## **Pulp Mill IIS Response to Review of Hydrodynamic Reports**

We have reviewed the comments made in Patterson Britton's letter to the Department of Environment and Water Resources (dated 30<sup>th</sup> March 2007). We welcome this third party review, and offer our response to each item, focussing on where specific queries have been raised.

**Figure 1: Comparison of results generated near Devonport along the Tasmanian coast by combined action of tide and low-frequency sea-level motion (red) versus tide only (black):**

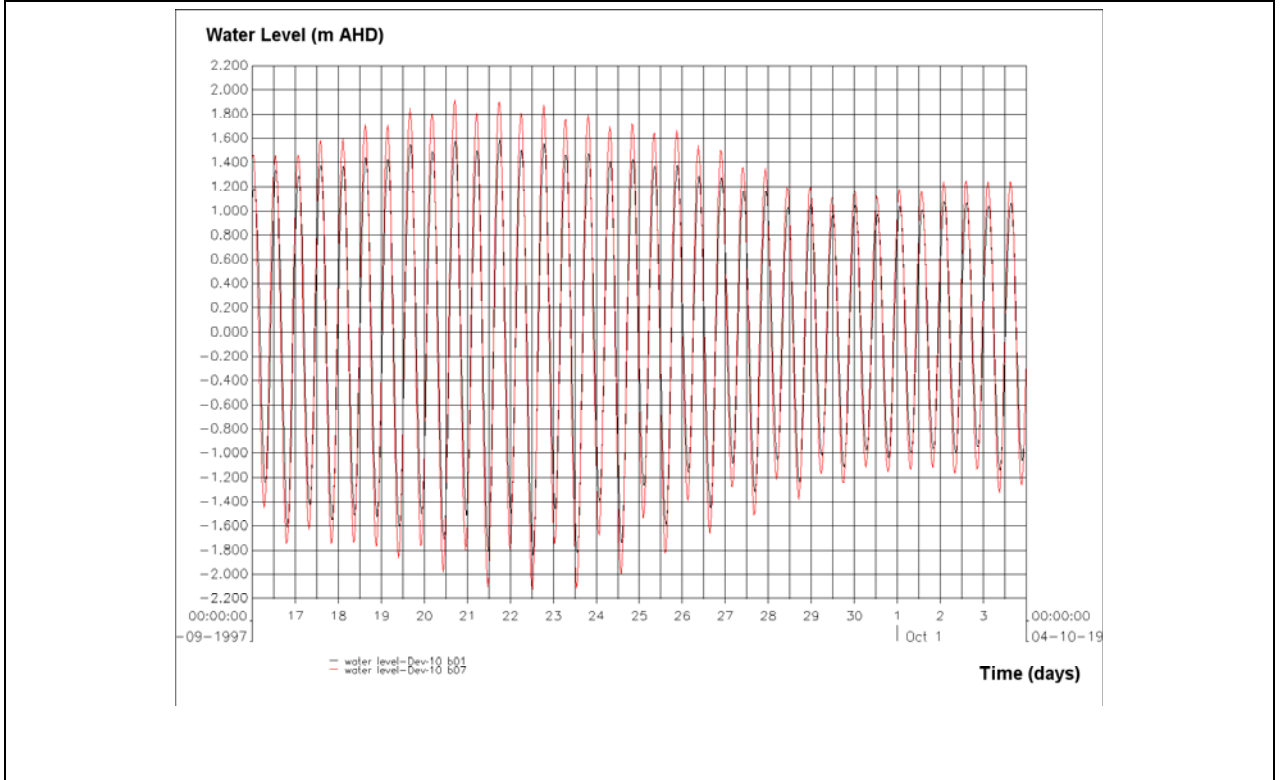
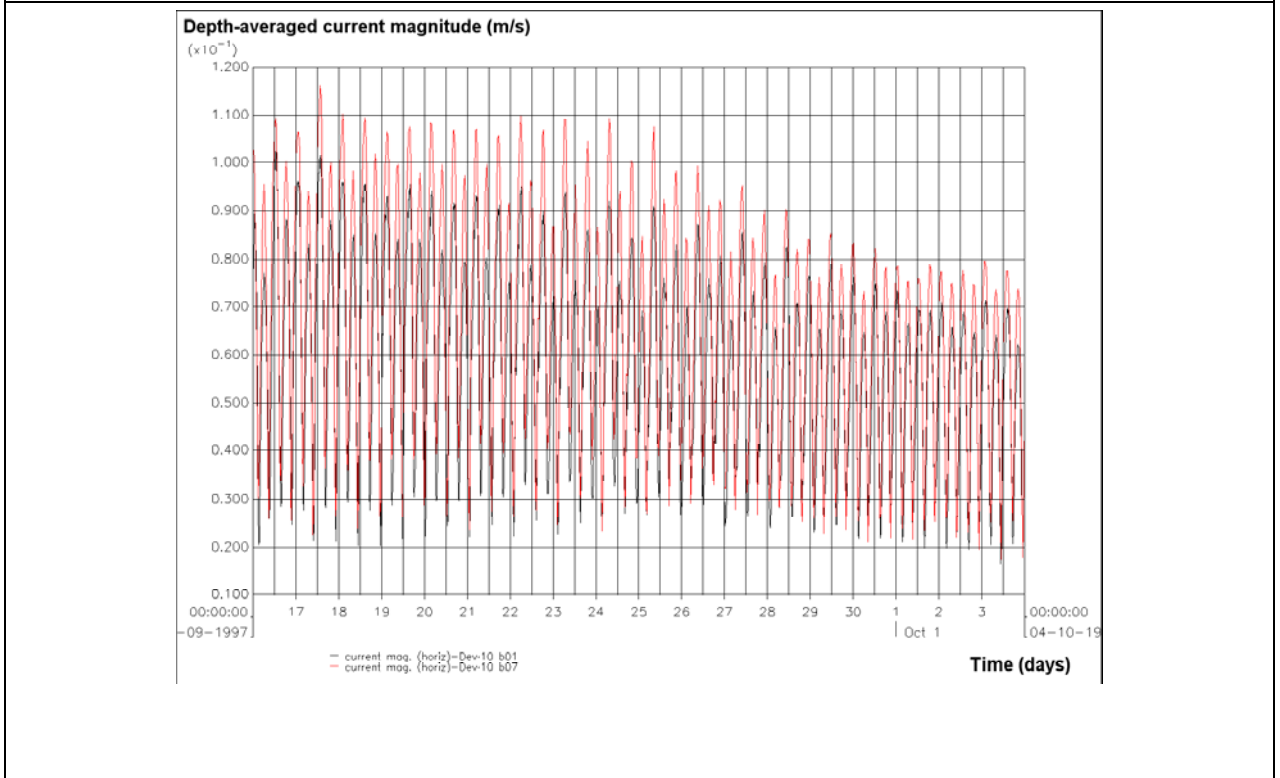
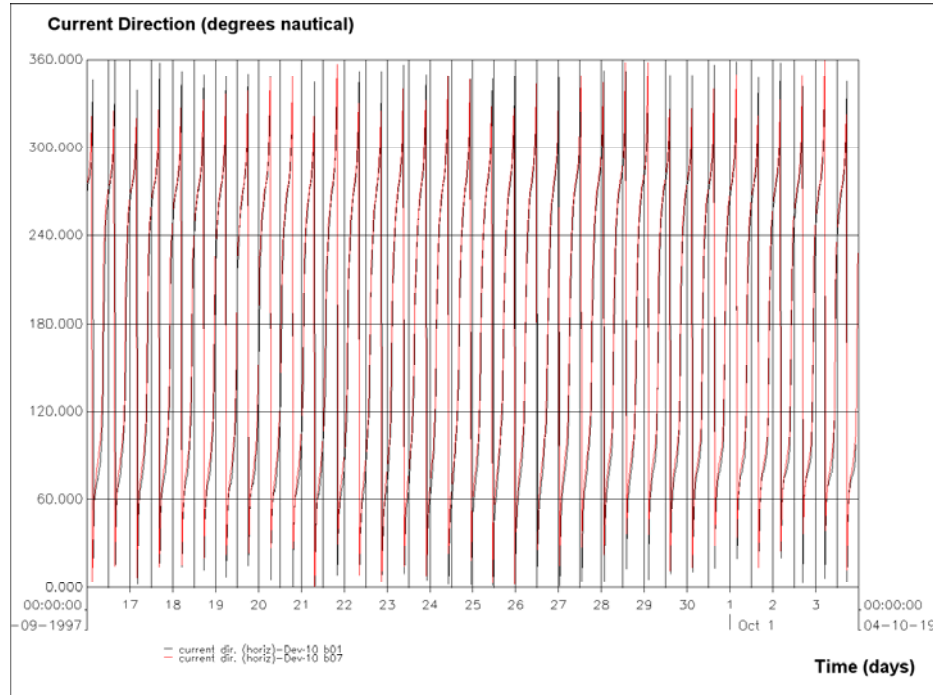
However, a query has been raised as to whether East Coast Lows should have been specifically modelled. The following comments are therefore offered in relation to:

- ▶ the capability of the model to represent low-frequency sea-level motion, and
- ▶ the need to model East Coast Lows for this part of Bass Strait.

- ▶ Results from a run focussing on the Victorian coastline (i.e. completed for another project) and inclusive of low frequency sea-level variability have been extracted at a location near Devonport (depth of approximately 19 m with respect to MSL). These results have then been compared to tide-only results (refer Figure 1). The effect of winds on hydrodynamics is not part of this comparison.

The comparison suggests that:

- ▶ Under the effect of low frequency sea-level variations, tidal amplitude peak and current magnitude may increase by as much as 0.6 m and 0.02 m/s, respectively;
- ▶ Inclusion of low frequency sea-level variations in the analysis has led to a relatively uniform, steady **increase** in predicted tidal amplitudes and peak currents along the Tasmanian coast;
- ▶ No significant change in current magnitude and direction is observed which is attributed to the fact that the numerical monitoring station adopted in the comparison is in relatively deep waters (approx. 19 m at MSL).
